**PP201/2012-3**

**15 Karingal Drive WYE RIVER**

**Construction of a Single Dwelling & Removal  
of Two (2) Trees**

# Application to AMEND a Planning Permit

**NOT FOR CONSTRUCTION PURPOSES**

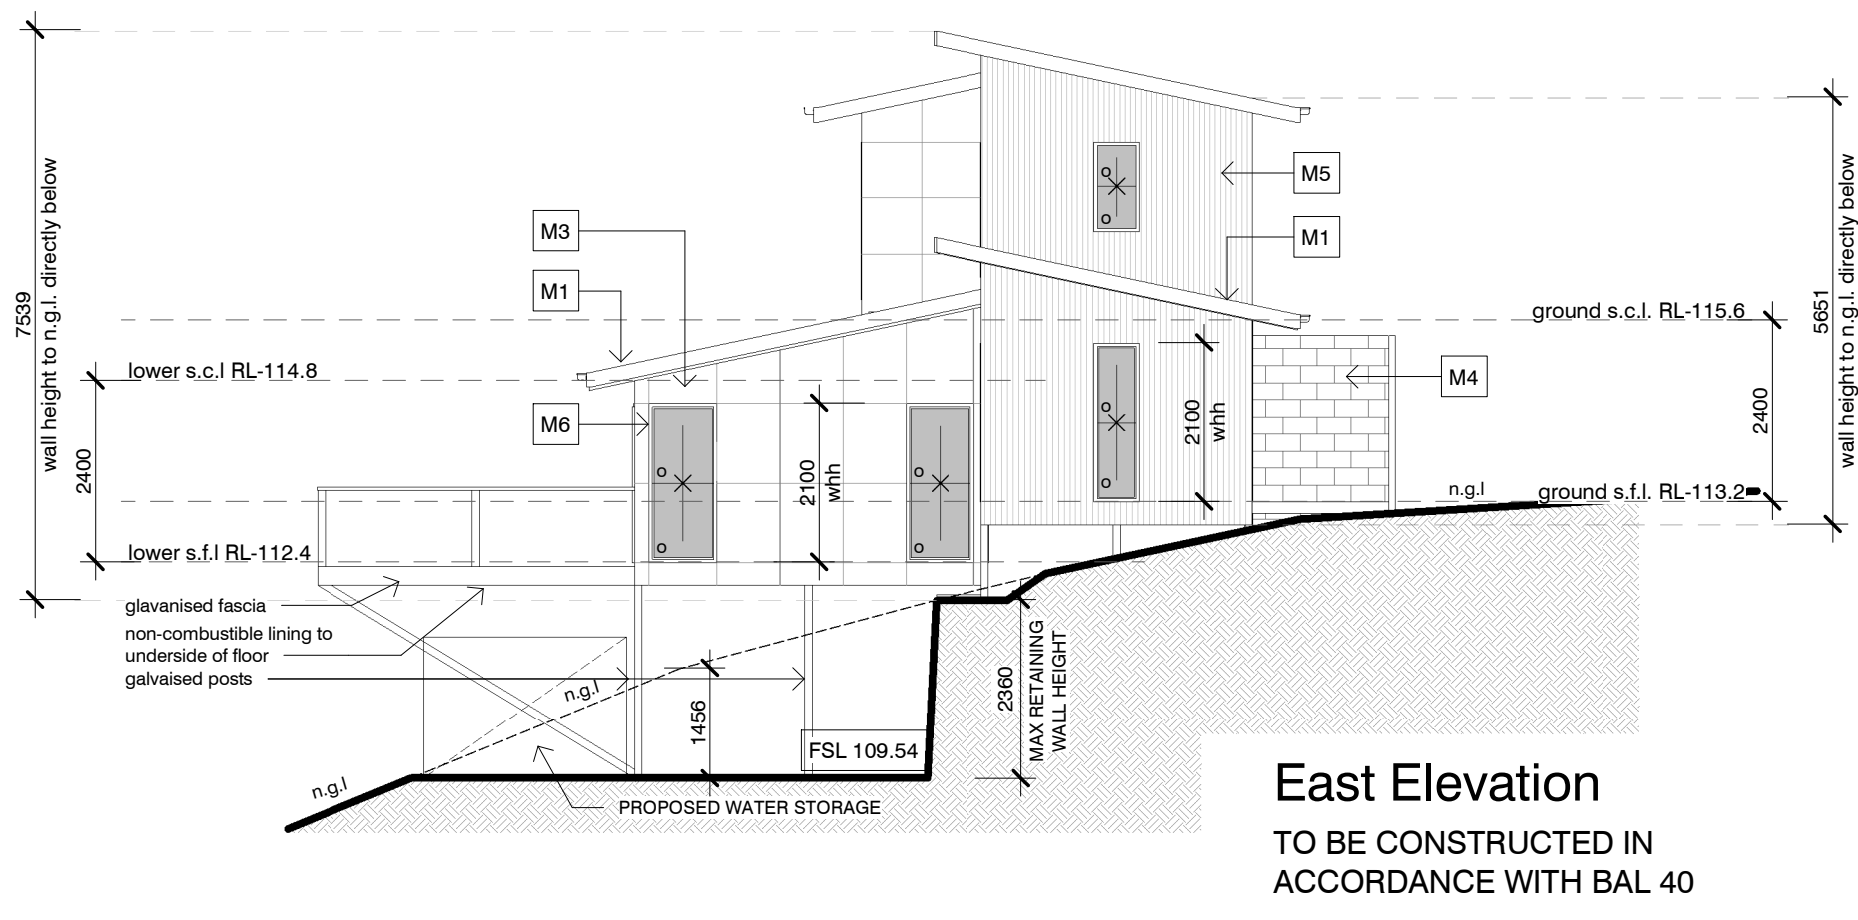
Rev G: Add First Floor 25.01.19  
Rev F: TP F1 07.05.18 Council Change  
Rev E: TP F1 04.05.18 Council Change  
Rev D: TP F1 02.05.18 Council Change  
revision: Rev C: TP F1 17.04.18 Bath Layout Change  
revision: Rev B: TP F1 21.03.18
